HENDERSON COUNTY

MEMORANDUM

SUBJECT: Tabled Phase I Development Plan for the Seven Falls Golf and River

Club (File # 2007-M19)

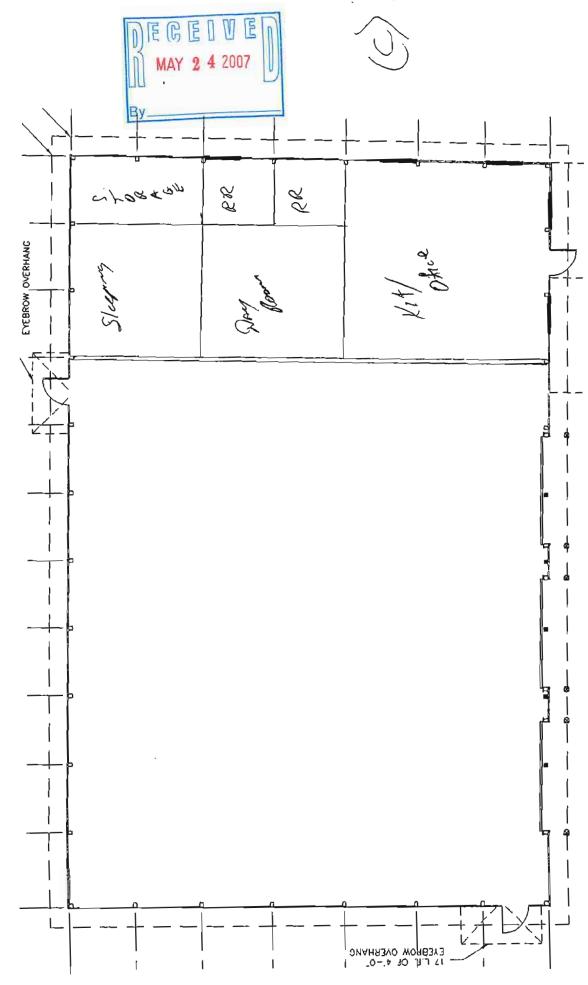
The developer's offer to provide the land and shell construction costs for an Etowah Horse-Shoe Fire & Rescue sub-station addresses our concerns about the provision of fire services. I have attached a preliminary drawing of an acceptable sub-station for consideration.

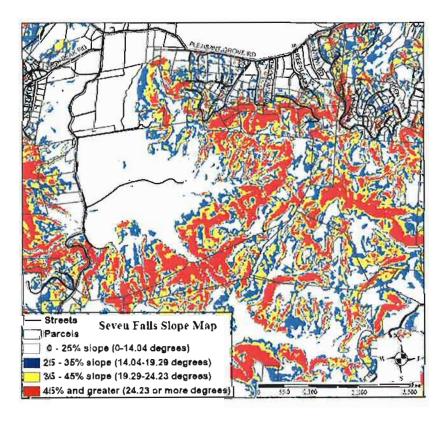
13. Slopes. Below is a slopes map of the approximate location of Phase I. This map has been provided for informational purposes only. Pursuant to the goals of the CCP, the applicant should work to protect steep slopes and leave them in their natural state with only limited development. Note: Henderson County does not have any regulations for development on steep slopes. The Planning Board can only require the applicant to meet the minimum standards of the Subdivision Ordinance.

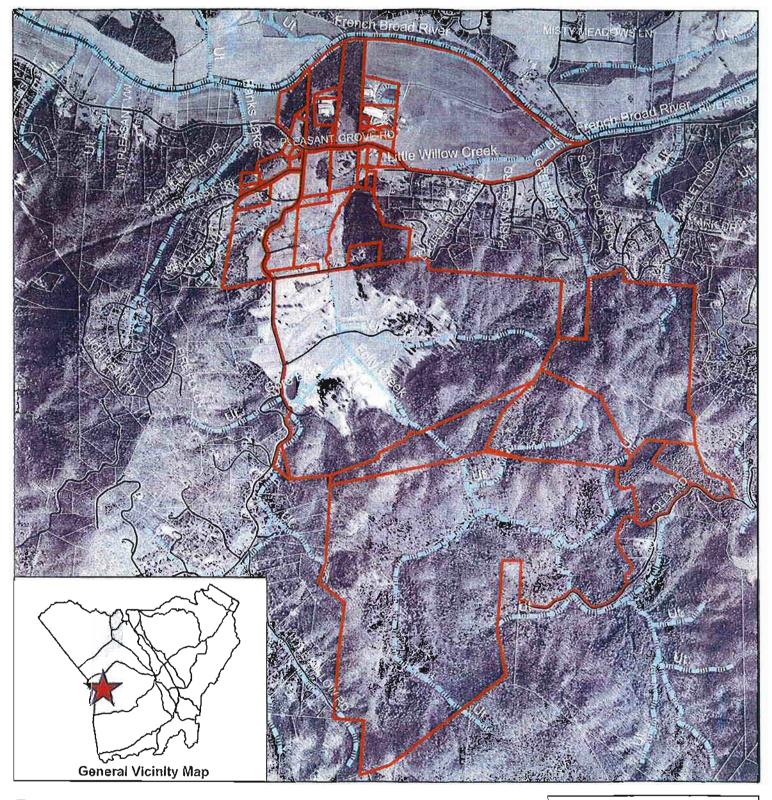
19. **Slopes.** Below is a slopes map of the approximate location of Phase I. This map has been provided for informational purposes only. Pursuant to the goals of the CCP, the applicant should work to protect steep slopes and leave them in their natural state with only limited development. Note: Henderson County does not have any regulations for development on steep slopes. The Planning Board can only require the applicant to meet the minimum standards of the Subdivision Ordinance.
